Duke Energy Carolinas, LLC (Duke Energy)
Oconee Nuclear Station (ONS), Units 1, 2, and 3
Docket Numbers 50-269, 50-270, 50-287
Renewed License Numbers DPR-38, DPR-47, DPR-55

Subject: Duke Energy Response to NRC Request for Additional Information (RAI) Related to Oconee License Amendment Request 2017-05

Duke Energy Response to NRC Request for Additional Information (RAI)

KEOWEE ELECTRICAL DISTRIBUTION

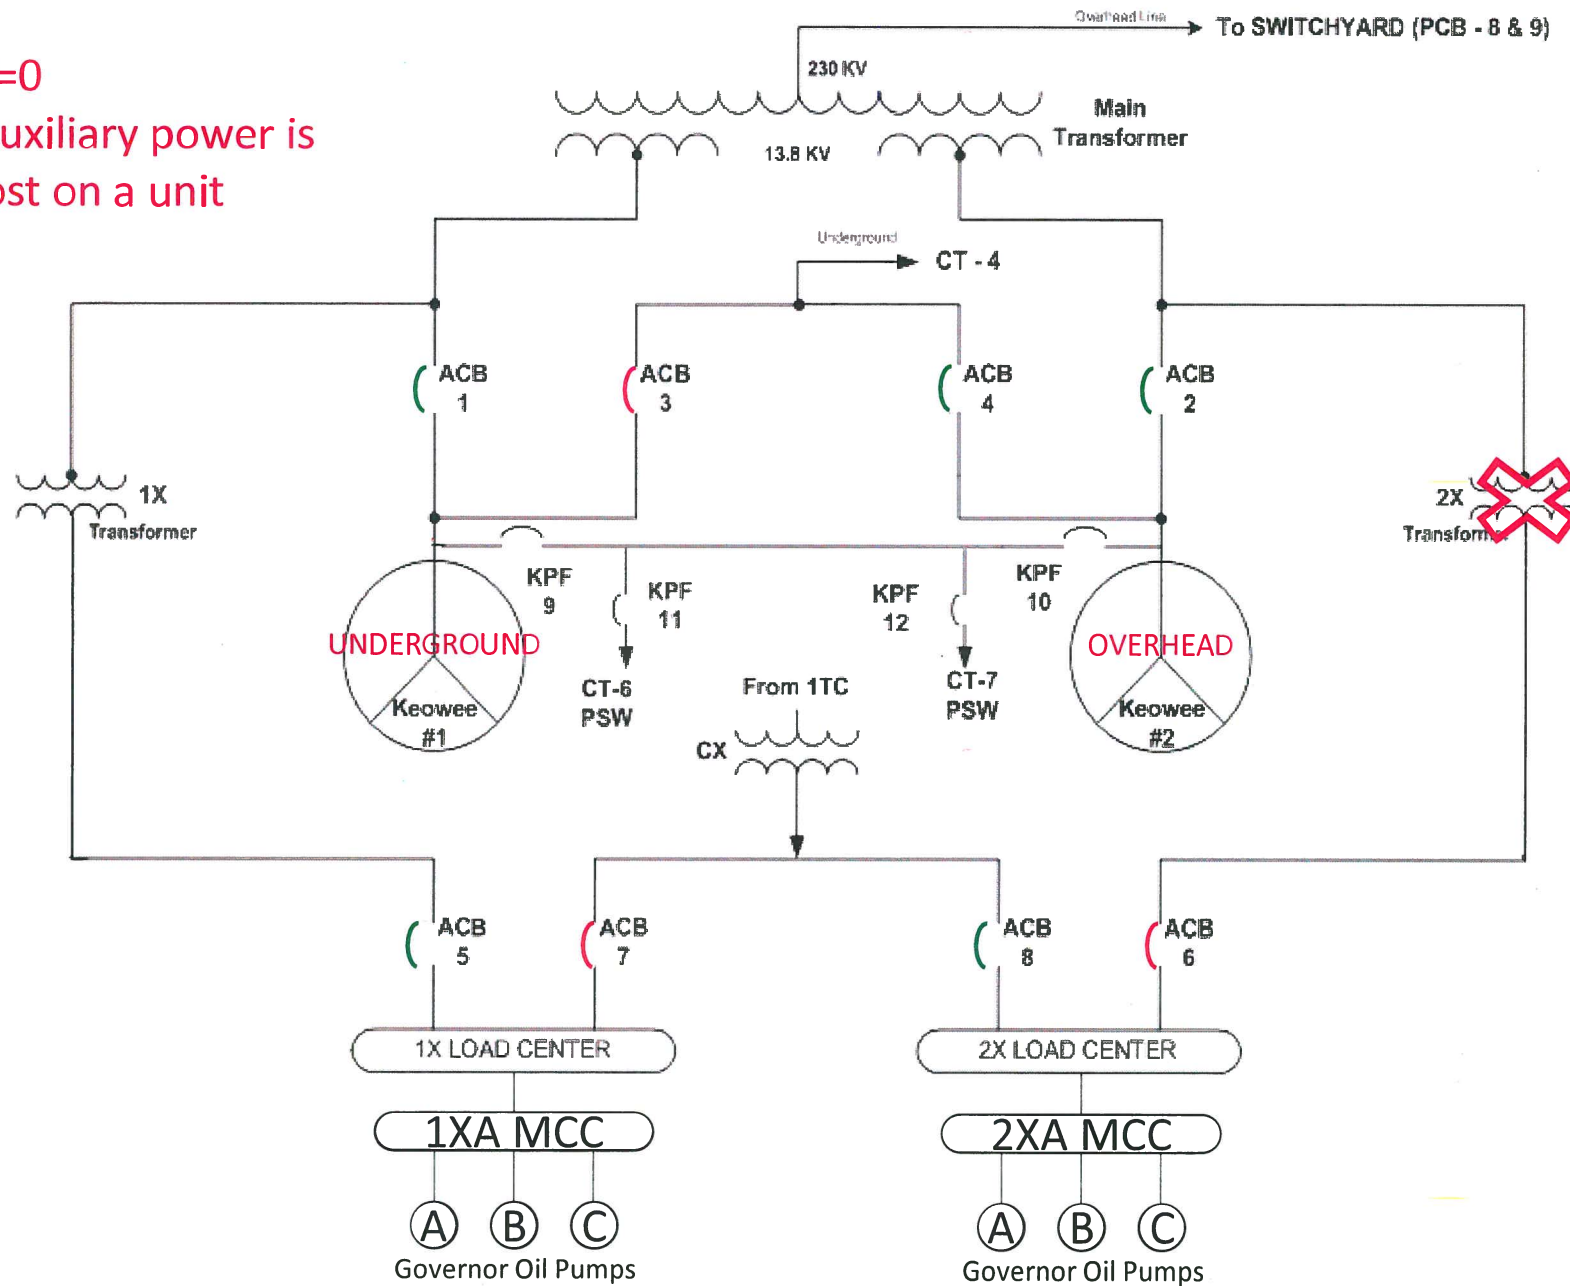
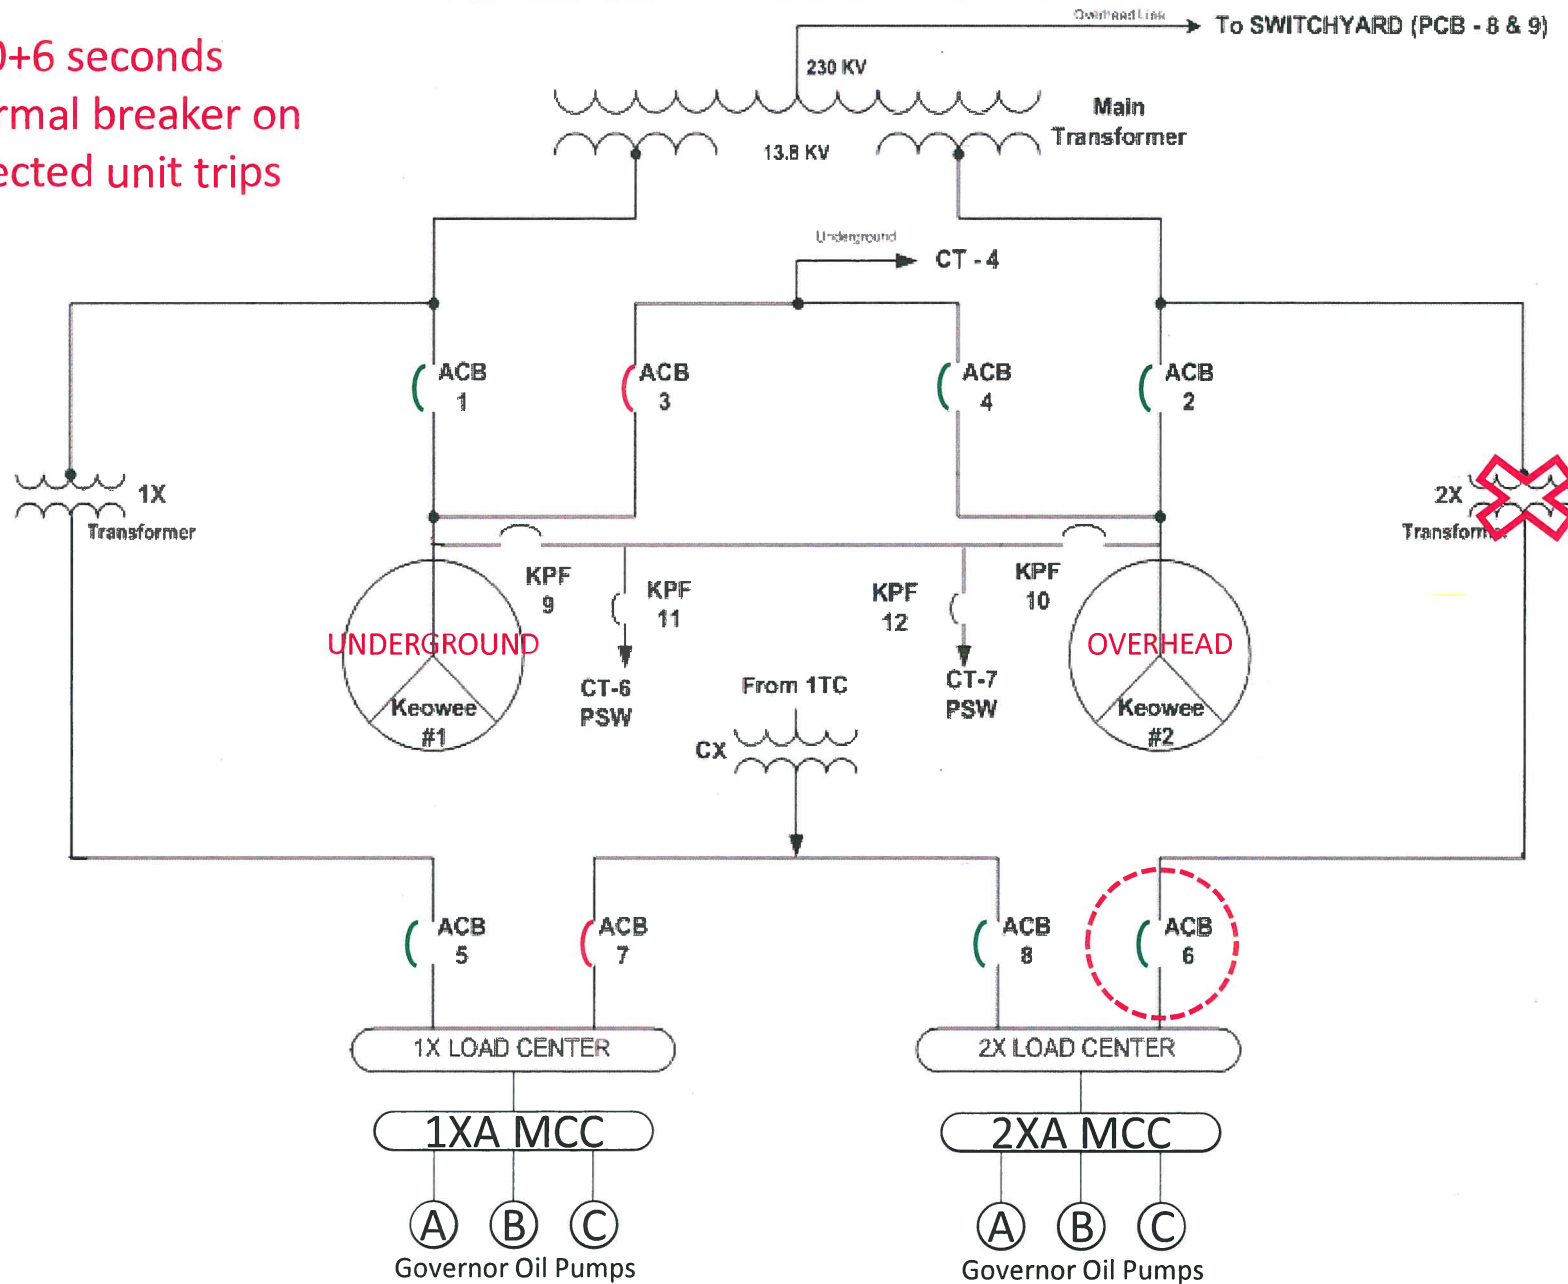
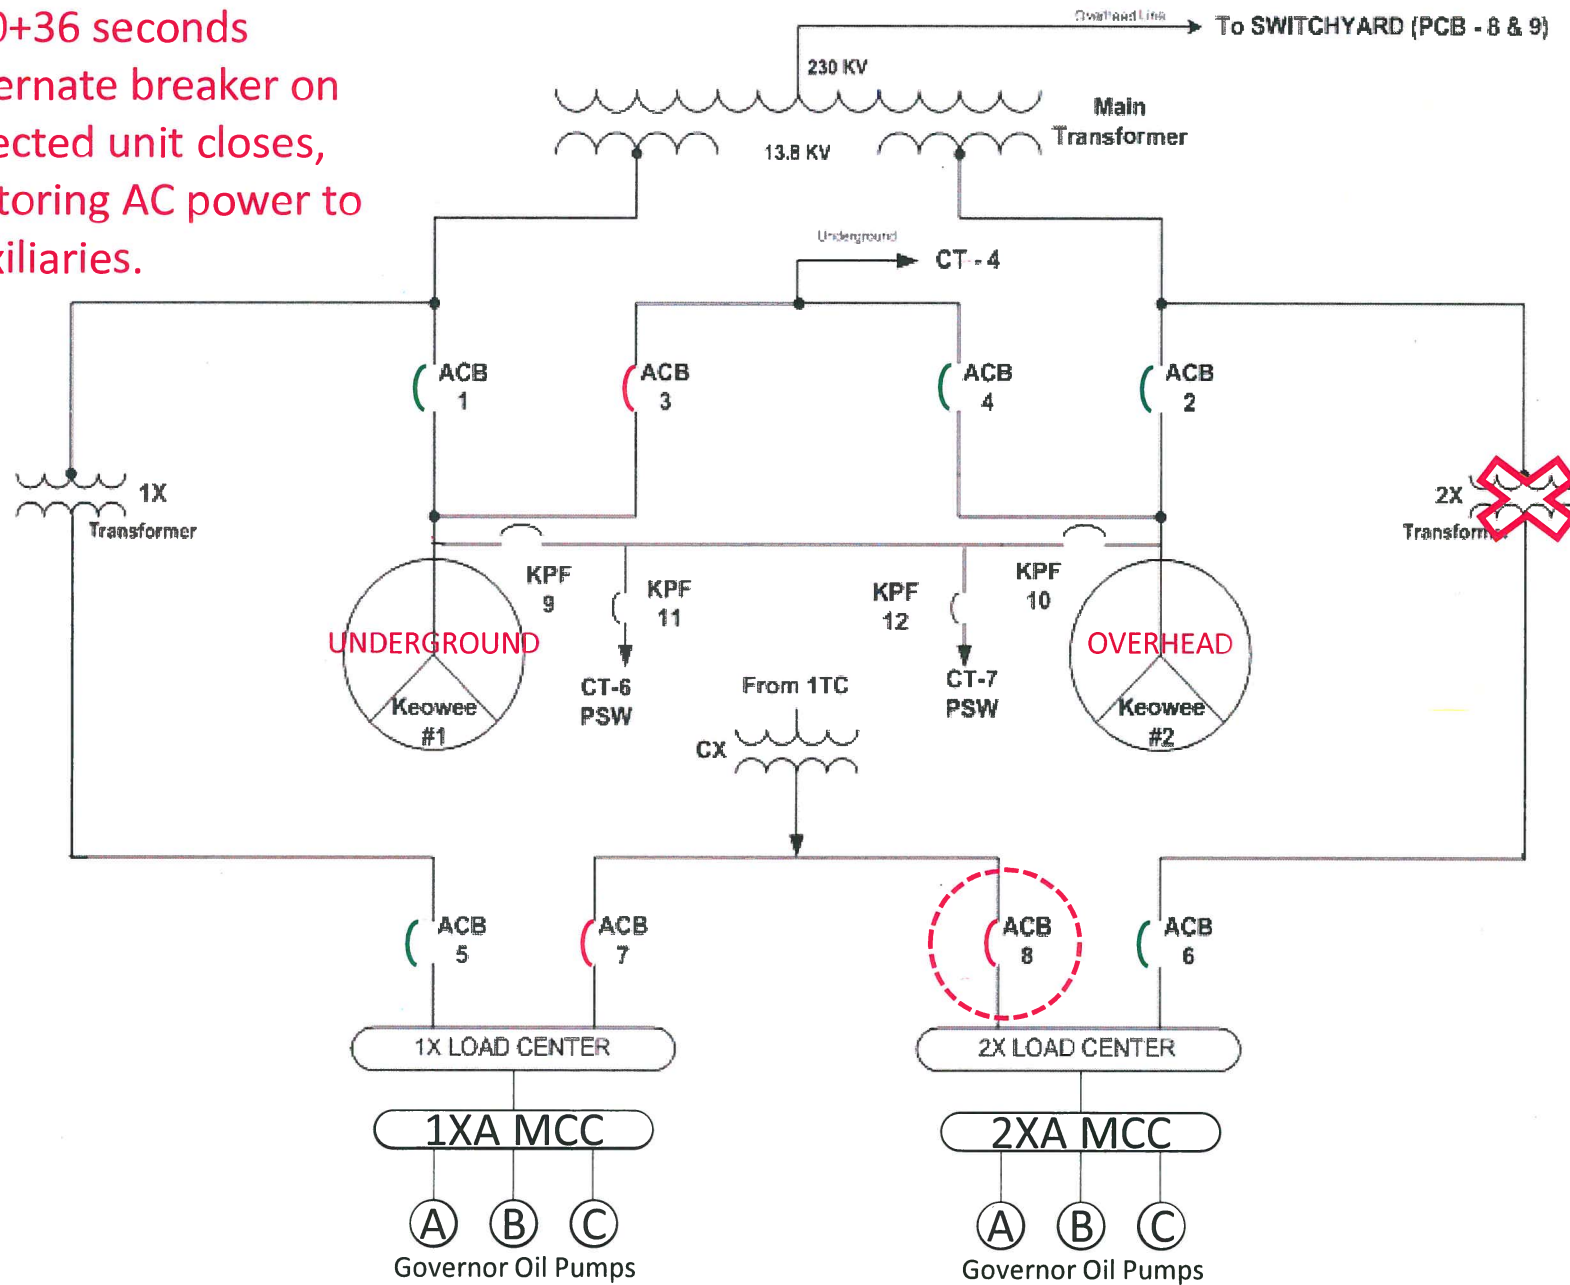
- a. Logic and/or electrical diagrams showing breaker alignment for normal and alternate auxiliary power sources, including associated breakers and buses fed from these auxiliary power sources, and a comparison of these diagrams to Figure 1 of the application with respect to Zone Overlap Circuitry.
- b. The staff requests the licensee to provide high-level system descriptions of: (1) the governor oil system, including the breaker alignment for normal and alternate power sources that feed the accumulators; and (2) the normal and auxiliary power swaps to the load centers.
- c. Legible versions of UFSAR figures 8.1, 8.3 (page 1 of 2), and 8.4 (all three pages).

- a. An annotated version of LAR Figure 1 has been prepared to demonstrate the logic and breakers involved in the auxiliary power circuitry. See the RAI-5 Supplemental Response Information that follows.

T=0
Auxiliary power is
lost on a unit

T=0+6 seconds
Normal breaker on
affected unit trips

T=0+36 seconds
Alternate breaker on
affected unit closes,
restoring AC power to
auxiliaries.
